# HT813 Firmware Release Notes

## FIRMWARE VERSION 1.0.15.7

HT813

01/03/2023

### Always send HTTP Basic Authentication Information

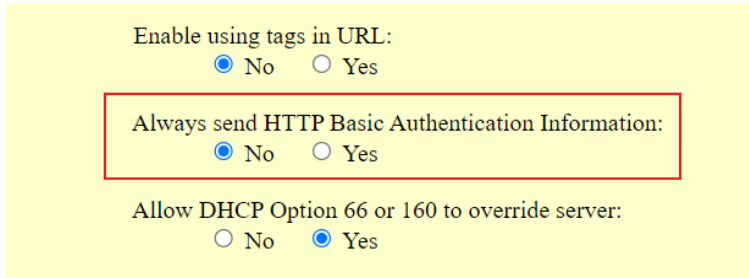
**Always send HTTP Basic Authentication Information:**  
 No  Yes

This feature allows users to configure user name and password within HTTP request before server sends authentication challenge.

Pvalue	Description	Value range	Default
20713	Always send HTTP Basic Authentication Information	0 – No 1 - Yes	0 – No

### Enable using tags in the URL

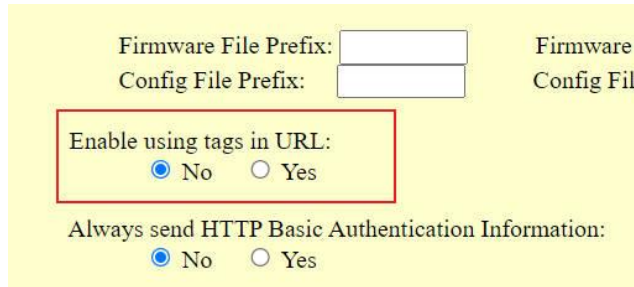
**Enable using tags in the URL:**  
 No  Yes

This feature allows users to configure variables on the configuration server path to differentiate the directories on the server.

Pvalue	Description	Value range	Default
8609	Enable using tags in the URL	0 - No 1 - Yes	0 - No

### Configuration File Types Allowed

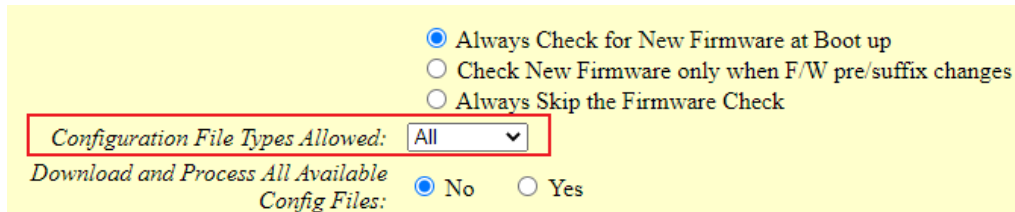
This feature allows users to configure provision configuration file type in xml file only or all file types.

Pvalue	Description	Value range	Default
8601	Configuration File Types Allowed	47 - All 46 - XML only	47 - All

### Additional Override DHCP Option

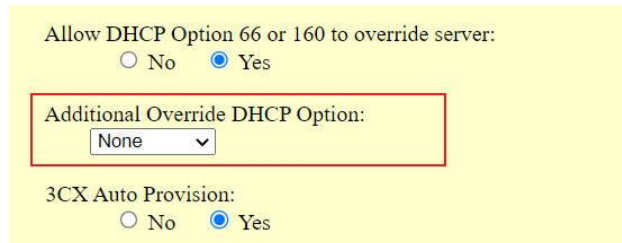
This feature allows users to enable the Additional Override DHCP Option in Option 150.

Pvalue	Description	Value range	Default
8337	Additional Override DHCP Option	0 – None 1 – Option 150	0 – None
